Amendments to the Drawings:

REMARKS

FIG. 11A

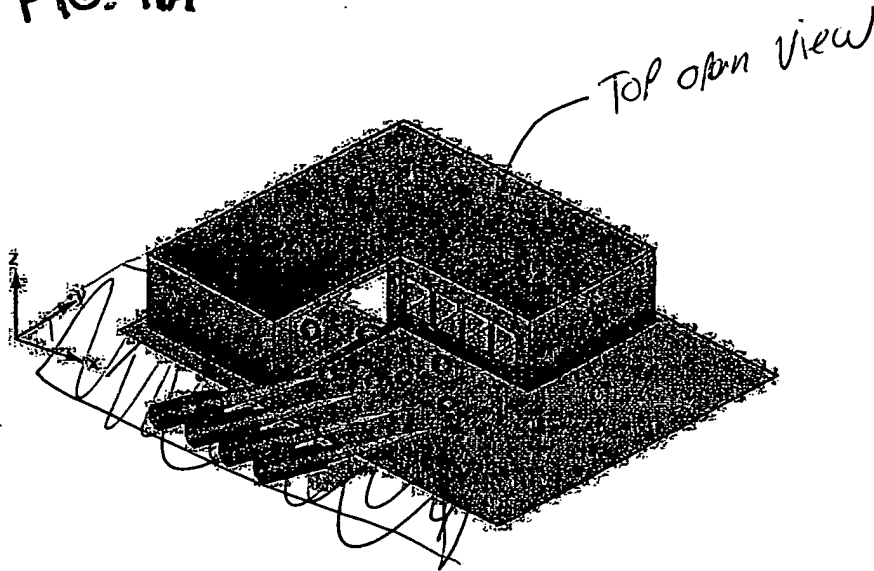
The attached single sheet of drawings include changes to Figs. 11A and 11B:

The Examiner has objected to the drawings. The Examiner argues that "all of the claimed structures encompassed by claims 1 – 8, 11 – 18, 21 – 30, 87 – 89, 93 – 95, 97 – 101 and 109 – 116 must be shown or the feature(s) canceled from the claim(s)." (Office Action, p.3).

Sheet 1, which includes Figs. 11A and 11B, replaces the sheet that includes Figs. 11A and 11B.

As noted above claims 1-116 are cancelled. A corrected drawing showing the structures of the currently claimed invention is herein submitted. Specifically, the corrected drawing illustrates that the non-planar elements are an integral part of the microfluidic chip and have a surface defining the opening which comprises portions of a wall of a cell chamber.

FIG. 11B

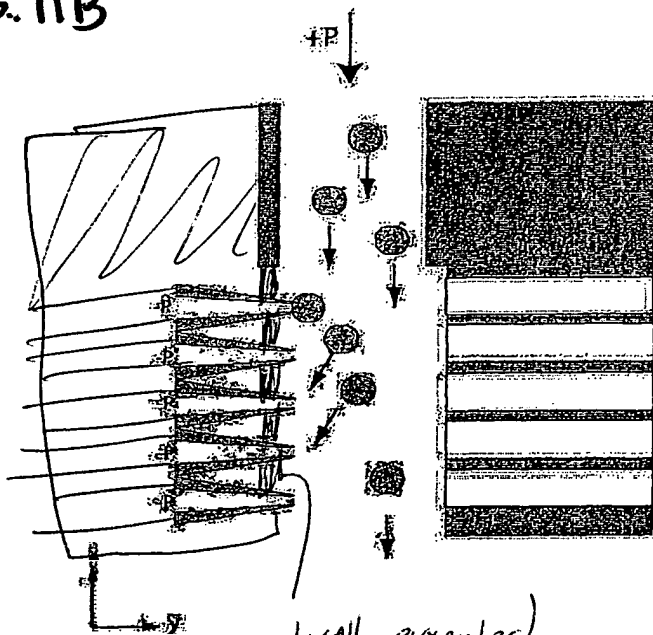
Wall extended
Nonplanar element is integral part of chip
